ACCESS REPORT

STATE SIGNIFICANT DEVELOPMENT APPLICATION SSDA 7689

WALSH BAY ARTS PRECINCT

4th November 2016

Pier 2 / 3 Ground Floor Level

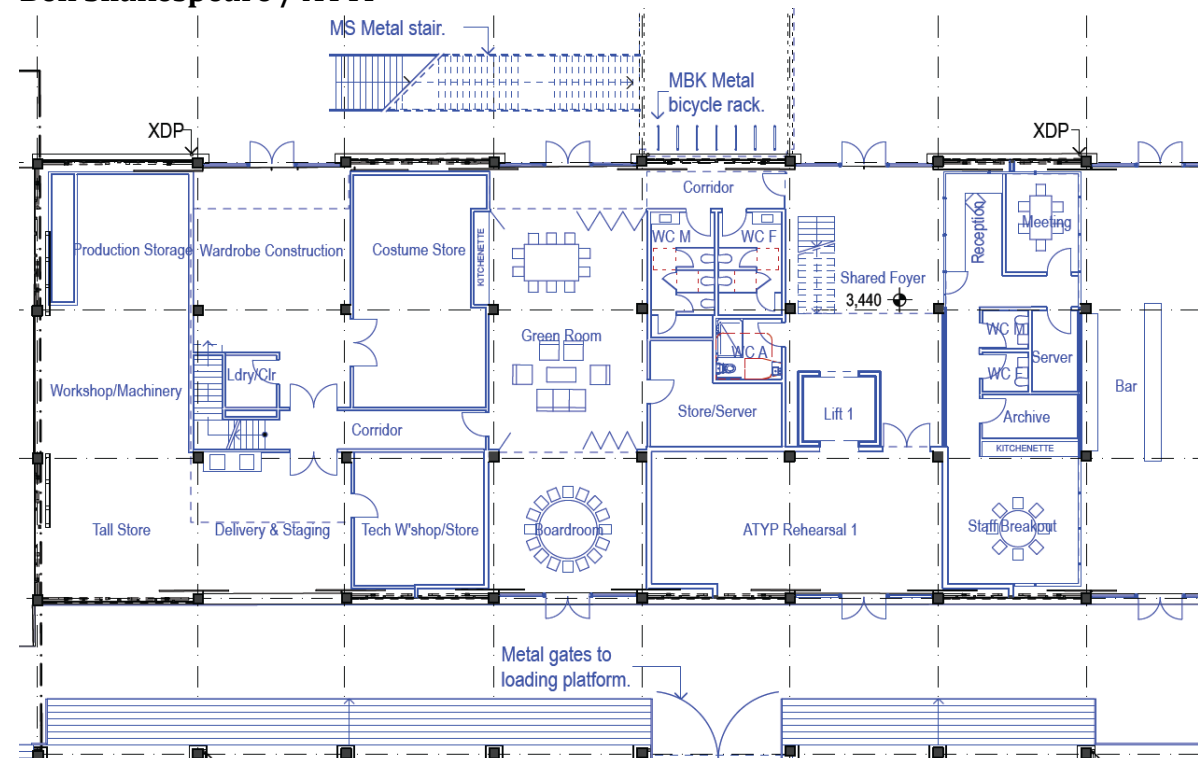
41. The foyer area adjoining Lift 1 provides adequate access and circulation spaces to approach various doorways and lift to comply with ASI428.1.
42. External doorways to the Green Room, Boardroom, ATYP Rehearsal 1 and Wardrobe also provide accessible entry / exits that will comply with ASI428.1.
43. The internal access corridors interconnecting the Green Room, Wardrobe, Shared Foyer 1, staff amenities and ATYP rehearsal provide 1600mm minimum width and 530mm minimum latchside clearance to the doors.

BCA / DDA Access Code Review	Compliance
44. The remainder of the accessways and doorway circulation spaces will comply with ASI428.1.	ES
45. Sanitary facilities – The sanitary facilities include a unisex wheelchair accessible toilet and ambulant accessible male and female cubicles that comply with ASI428.1 to satisfy F2.4 of the BCA.	YES

46. However, to fully satisfy the DDA the plans should be amended to include a wheelchair accessible shower and locker.	YES
47. Stairways – The plans show several internal stairways in this area which require handrails on both sides with extensions at landings and other features as specified by ASI428.1 and ASI428.4.1 to satisfy D3.3, D2.14 and D3.8 of the BCA.	YES Can Comply

48. Lift – The design shows a single lift No. 1 located centrally in the foyer area that will travel all four levels and provide a significant lift car of at least 2200mm X 2200mm to accommodate stage equipment and the like and will readily suit people using wheelchairs and facilitate high volume passenger movements.	YES

49. At levels 1 and 2 the design allows for movement of people to an alternate lift in the event of a breakdown while the mezzanine area of Bell Shakespeare is isolated from other fitout areas.	YES

Public Foyer, Commercial Tenancy 1 & Amenities

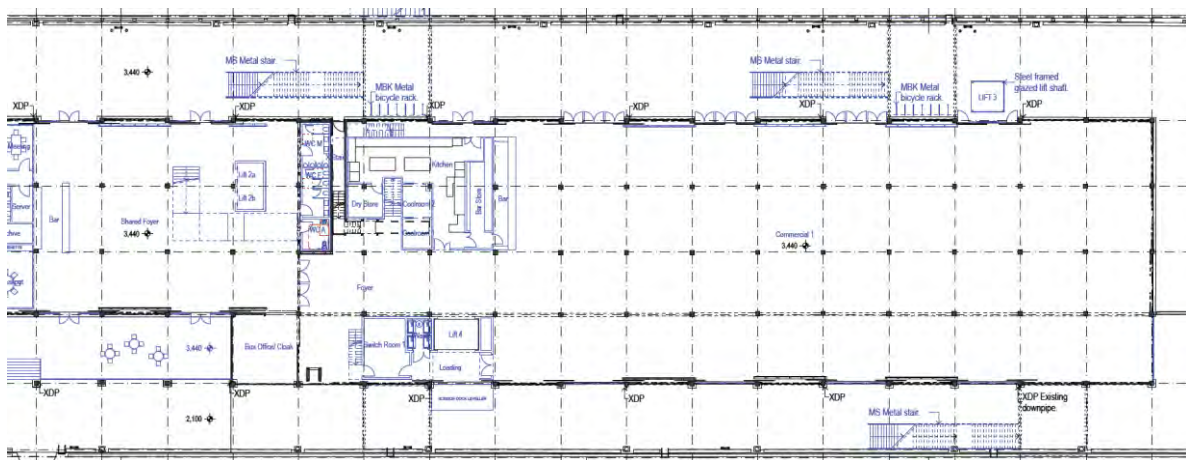
50. The large public foyer adjoining Lifts 2a and 2b proposes double door entrances that provides ample access and circulation spaces to approach various doorways and lifts to comply with ASI428.1.
51. Box Office & Cloaking are adjoining the shared foyer will achieve appropriate access complying with ASI428.1.
52. Commercial tenancy No. 1 proposes multiple external doorways that will provide appropriate access to comply with ASI428.1. The tenancy area proposes a large open plan area with double height void area with bar and kitchen facilities at the southern end and goods lift 4, loading dock and switch / plant room.

BCA / DDA Access Code Review	Compliance
53. Sanitary facilities – The sanitary facilities include a unisex wheelchair accessible toilet and ambulant accessible male and female cubicles that comply with AS1428.1 to satisfy F2.4 of the BCA.	YES

54. Stairways – The plans show a stairway in the large public foyer area and a stairway to the public sanitary facilities and stairway to an event store/lift 4 at the mezzanine level which require handrails on both sides with extensions at landings and other features as specified by AS1428.1 and AS1428.4.1 to satisfy D3.3, D2.14 and D3.8 of the BCA.	YES

55. Lifts – The design shows two lifts No. 2a & 2b located centrally in the foyer area that will travel all three levels and provide a significant lift car of at least 2200mm X 1800mm to accommodate two people using wheelchairs and facilitate high volume passenger movements.	YES

56. At levels 1 and 2 the design allows for movement of people to an alternate lift in the event of a breakdown.	YES
57. Lift 3 is an external lift that will provide direct access to the ACO on levels 1 and 2. The lift will provide a significant lift car of at least 2600mm X 2800mm and easily accommodate two people using wheelchairs and facilitate high volume passenger movements.	YES

58. Lift 4 is essentially a goods lift in a back of house area and will travel all four levels and is the only lift serving the mezzanine commercial area.

Pier 2 / 3 Mezzanine Floor Level

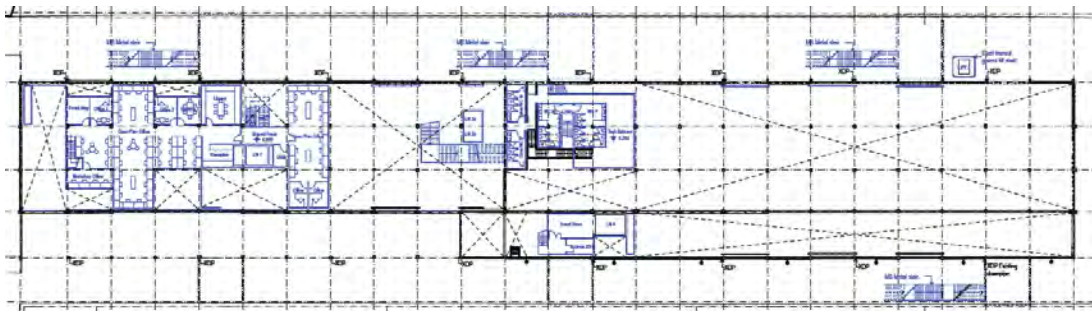
59. The mezzanine level foyer / lift landing area provides 2700mm X 7800mm and facilitates ample access and circulation spaces to approach doorways, lift 1 and the stairway to comply with AS1428.1.	YES
60. Reception / Office/Library areas - The accessways and doorway circulation spaces to and within all rooms in accordance with AS1428.1.	YES
61. Stairways – The plans show several stairways in this area which require handrails on both sides with extensions at landings and other features as specified by AS1428.1 and AS1428.4.1 to satisfy D3.3, D2.14 and D3.8 of the BCA.	YES Can Comply
62. Lift – The design shows a single lift No. 1 located centrally in the foyer area that will travel all four levels and provide a significant lift car of at least 2200mm X 2200mm to accommodate stage equipment and the like and will	YES

Bell Shakespeare / ATYP Level 1

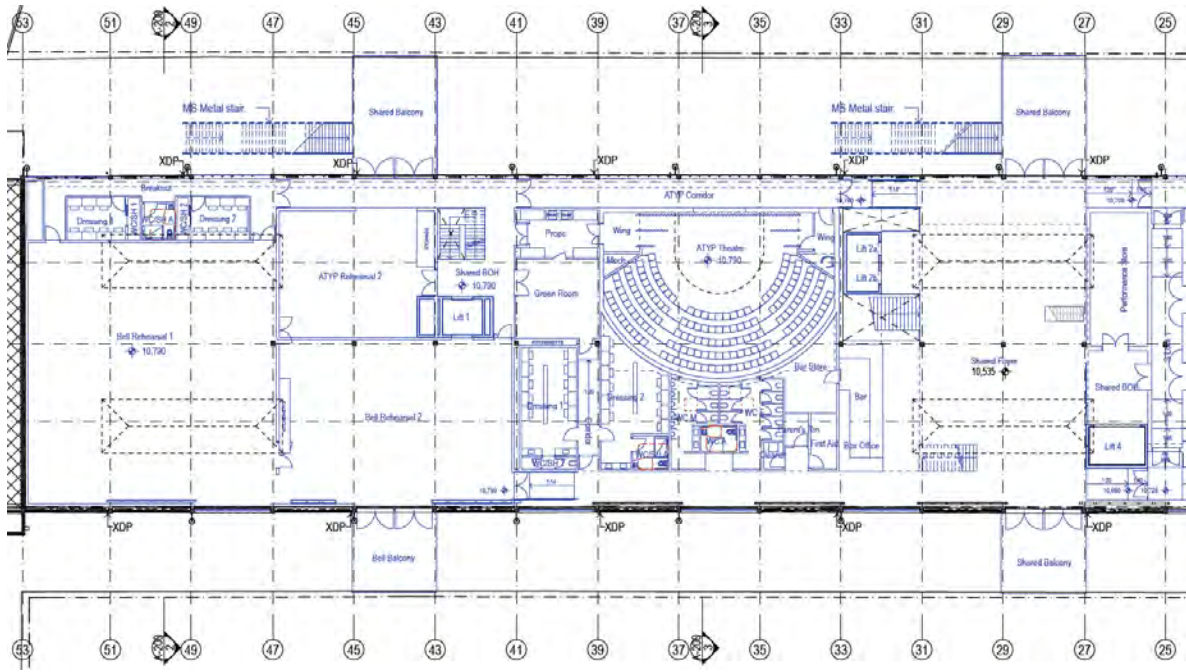
70. **Lift & Foyer Accessways** - Bell Shakespeare / ATYP areas at the southern end provide adequate access from Lift 1 to circulate and approach various doorways to dressing rooms, sanitary facilities rehearsal areas, Green Room facilities and through the props room and sound lock to theatre stage level to comply with AS1428.1 and enable inclusive access.

71. **Bell Balcony** adjoins Bell Rehearsal 2 and will provide a level threshold through double doorways which will be detailed to comply with AS1428.1.

72. **Shared Foyer** - With respect to public access the main public foyer provides direct access from Lifts 2a/2b to the Box Office/Bar area, sanitary facilities and ramp to enter the theatre at the lower level and facilitate opportunities for wheelchair accessible seating spaces, although the wheelchair seating is proposed at the top tier of seating from Level 2.

73. **Shared Balcony** adjoining the foyer will provide a level threshold through double doorways which will be detailed to comply with AS1428.1.
74. **AYTP Auditorium Access** – The sound locks on each side of the auditorium enable access to potential wheelchair accessible seating in the front row to comply with Table D3.9 of the BCA and potentially the stage area, pending the various stage installations.

75. **Sanitary facilities (public)** – The sanitary facilities include a unisex wheelchair accessible toilet and ambulant accessible male and female cubicles that comply with AS1428.1 to satisfy F2.4 of the BCA.

76. **Sanitary facilities (performers)** – The sanitary facilities adjoining dressing rooms that include two (2) unisex wheelchair accessible toilet /

BCA / DDA Access Code Review	Compliance
Pier 2 / 3 Level 2

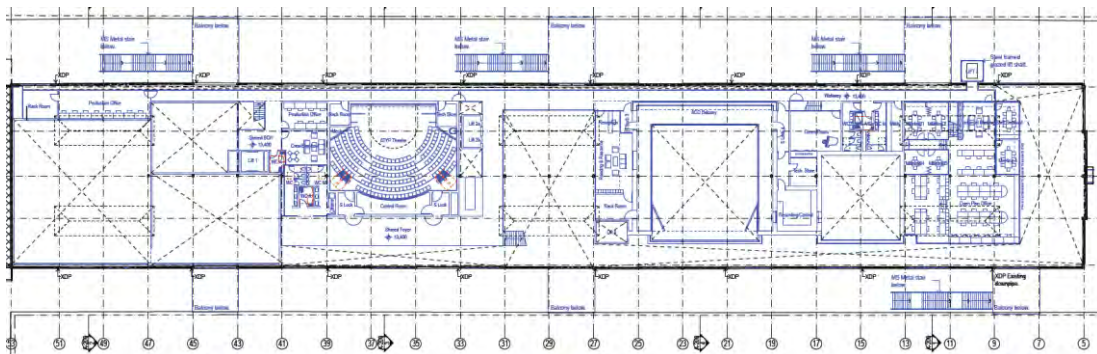
94. Level 2 proposes the upper levels of the ATYP Auditorium, ACO Auditorium balcony, various offices and sanitary facilities with a shared public foyer and corridor accessways that interconnect with Lifts 2a/2b to facilitate ease of movement for the public. Lift 1 also enables access to this level and includes controlled staff accessways within the Bell Shakespeare area and Lift 3 to the ACO to ensure equitable and inclusive access that complies with the BCA and DDA.

95. **Lift & Foyer Accessways** – The ATYP areas at the southern end provide adequate access from Lift 1 to circulate within back-of-house office areas with a corridor link to the public foyer areas, sanitary facilities and the AYTP auditorium.
96. With respect to public access the main public foyer provides direct access from Lifts 2a/2b to enter the theatre at the upper level and facilitate opportunities for wheelchair accessible seating spaces.
97. **Auditorium Access** – The sound locks on each side of the auditorium enable access to wheelchair accessible seating in the back row to comply with Table D3.9 of the BCA.

BCA / DDA Access Code Review	Compliance
98. The western corridor proposes 1600mm minimum width to facilitate Turning with several T-junctions to enable Passing in accordance with ASI428.1 and D3.3 of the BCA.	YES

Australian Chamber Orchestra (ACO) Level 2

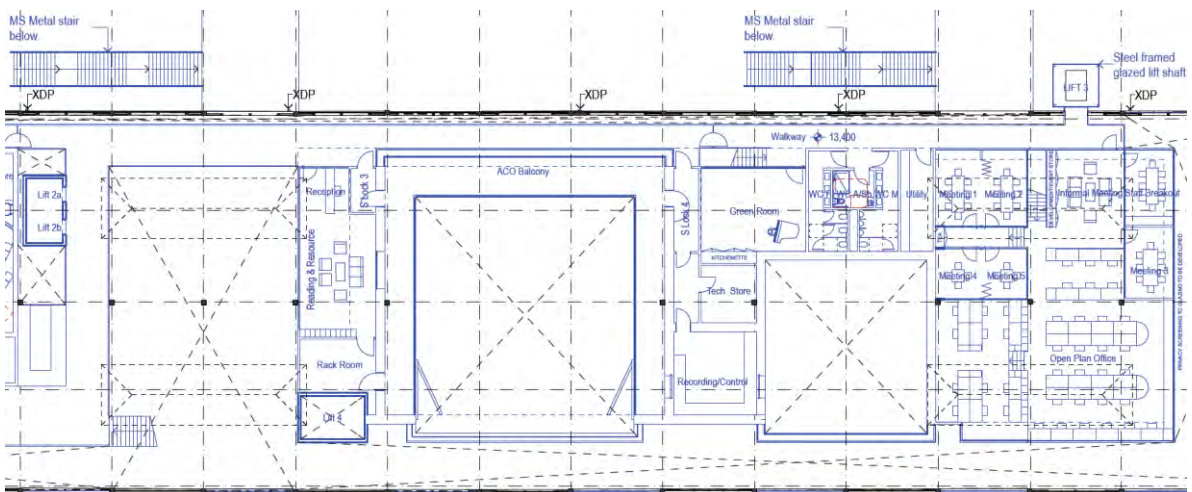
100. **Lift & Foyer Accessways** - The main public foyer incorporates Lifts 2a/2b and provides ample access and circulation spaces to approach various doorways to enter the ACO auditorium in accordance with ASI428.1.

101. Lift 3 and adjacent stairways provide alternate public access to Level 2 to access western corridor which facilitates level walkways to the ACO Auditorium, Green Room, associated back-of-house facilities, offices and meeting room to ensure equitable access that will comply with ASI428.1 and readily satisfy Part D3.3 of the BCA and DDA. The western corridor proposes 1600mm minimum width to facilitate Turning with several T-

BCA / DDA Access Code Review	Compliance
junctions to enable Passing in accordance with ASI428.1 and D3.3 of the BCA.	YES
102. ACO Offices & Meeting Room Access – The level 2 plans illustrate an office entry adjacent to Lift 3 with direct access to several meetings room and open plan workstation areas in a manner that provides continuous accessible paths of travel that will comply with ASI428.1 and satisfy D3.3 of the BCA.	YES

103. The ACO Office Area is split level due to the required ceiling heights within the acoustically insulated performance areas and practice rooms on the level below. Subsequently the office accommodation and small meeting rooms provided in this area is not wheelchair accessible. Nonetheless the majority of the office accommodation is accessible and can easily facilitate equitable access to employment and meeting areas to satisfy the performance requirements of the BCA and DDA.	YES

104. ACO Auditorium Access / Recording/Control Room – The sound locks 3 and 4 on each side of the ACO Auditorium enable access to the balcony areas to comply with ASI428.1 and D3.3 of the BCA. Sound Lock 4 also facilitates accessible corridor and doorway circulation spaces to enter the Recording Control Room to satisfy ASI428.1 and D3.3 of the BCA.	YES

105. ACO Sanitary facilities – The plans show male and female ambulant sanitary facilities and a unisex wheelchair accessible toilet that will comply with ASI428.1 and F2.4 of the BCA.	YES Can Comply

106. ACO Stairways – The plans show several stairways which require handrails on both sides with extensions at landings and other features as specified by ASI428.1 and ASI428.4.1 to satisfy D3.3, D2.14 and D3.8 of the BCA.

Ground Floor

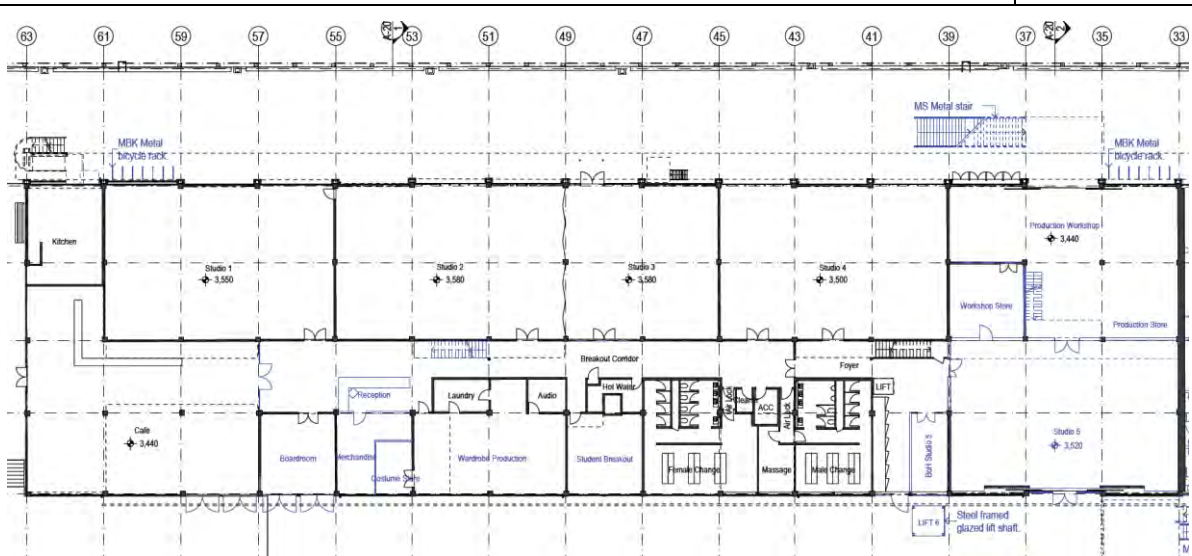
132. **Ground Floor** - The plans propose the existing internal café stair will be removed and a new double doorway entrance to the SDC reception areas which provides appropriate circulation spaces to comply with AS1428.1 and D3.3 of the BCA. Studio 5 indicates an external doorway

BCA / DDA Access Code Review	Compliance
<p>and the adjacent foyer show an external door which must be detailed to comply with ASI428.1 including circulation spaces.</p> <p>133. The new Merchandise room and reduced Costume Store can provide appropriate access subject to the entry door into the Wardrobe Production being re-installed as a 920mm door with 530mm latchside clearance.</p> <p>134. The new partitions and doorways adjoining Studio 5 and the Workshop provide appropriate access and circulation spaces to comply with ASI428.1 and D3.3 of the BCA.</p>	<p>YES can comply</p> <p>YES</p>

135. The ground floor plans indicate refurbished sanitary facilities which include a unisex wheelchair accessible toilet and while the size may not comply with ASI428.1 (2009) section 4.5 of the DDA Premises

Ground Floor Plan

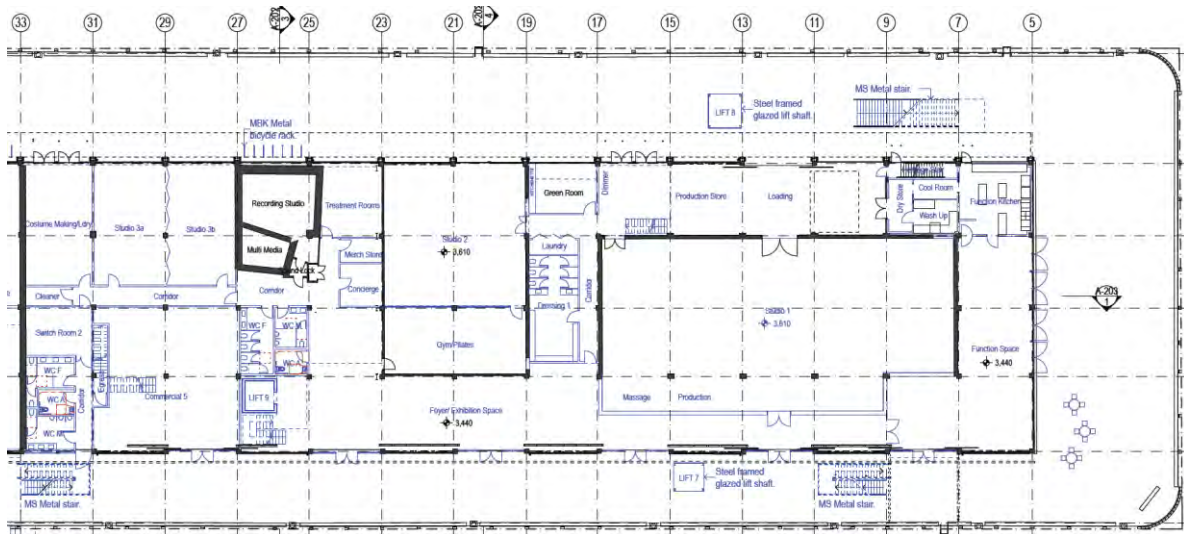
<p>Bangarra Dance Theatre</p> <p>141. Ground Floor - The plans multiple double doorways along the external façade of wharf 4 which enable entry to the Main Foyer and Exhibition Space and the northern Function Room which provide appropriate circulation spaces and can be detailed with accessible thresholds, doors and other features complying with AS1428.1 to facilitate equitable access to enter these areas and satisfy D3.2 of the BCA.</p> <p>142. The Main Foyer and adjoining corridors provide 1600mm minimum width, 1800mm X 2000mm Passing Areas in appropriate locations and direct access to the new lift to comply with AS1428.1. The doorway to the corridor adjoining the dressing rooms and Studio 3 corridor will require a minor adjustment to ensure 530mm latchside clearances while the stairway adjacent to the double doorway will require a 900mm minimum setback from the doorway to accommodate handrails and tactile indicators.</p> <p>143. Lifts – The design shows a new lift No. 9 located centrally in the main foyer area that will travel to the mezzanine level and provide a significant lift car of at least 2000mm X 1800mm to accommodate two people using wheelchairs and facilitate high volume passenger movements.</p>	<p>YES</p> <p>YES Can Comply</p> <p>YES</p>

Mezzanine level

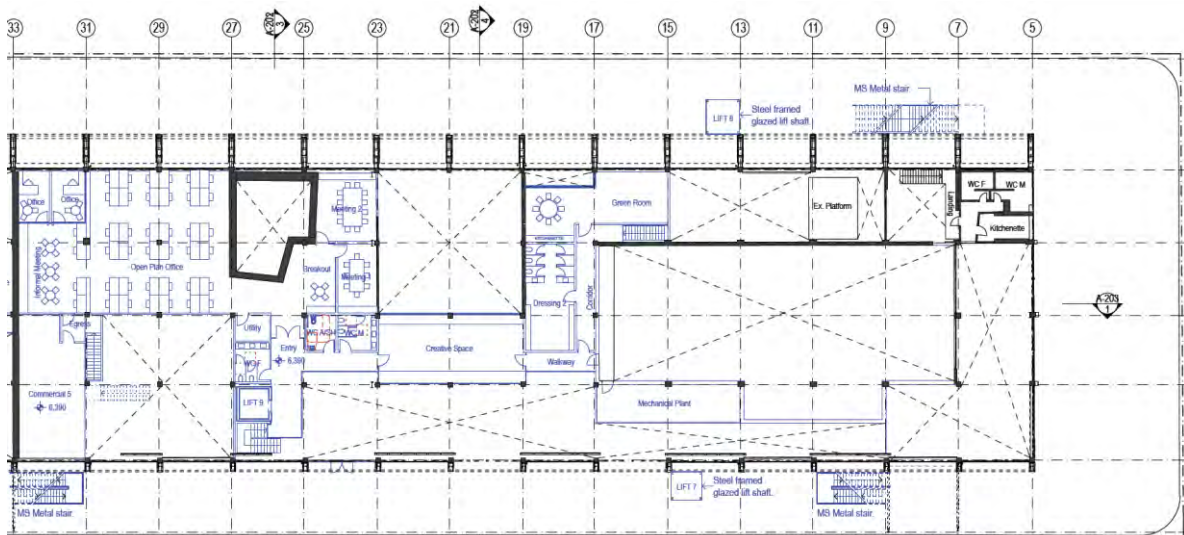
144. **Mezzanine Level** - The corridor accessways throughout the mezzanine level propose 1600mm–2000mm width to approach doorways to enter rooms in accordance with AS1428.1 to satisfy D3.3 of the BCA.
145. **Sanitary facilities** – There are sanitary facilities on both levels which include a unisex wheelchair accessible toilet and ambulant accessible male and female cubicles that comply with AS1428.1 to satisfy F2.4 of the BCA.
146. **Stairways** – The plans show several stairways to access the mezzanine level which require handrails on both sides with extensions at landings and other features as specified by AS1428.1 and AS1428.4.1 to satisfy D3.3, D2.14 and D3.8 of the BCA.
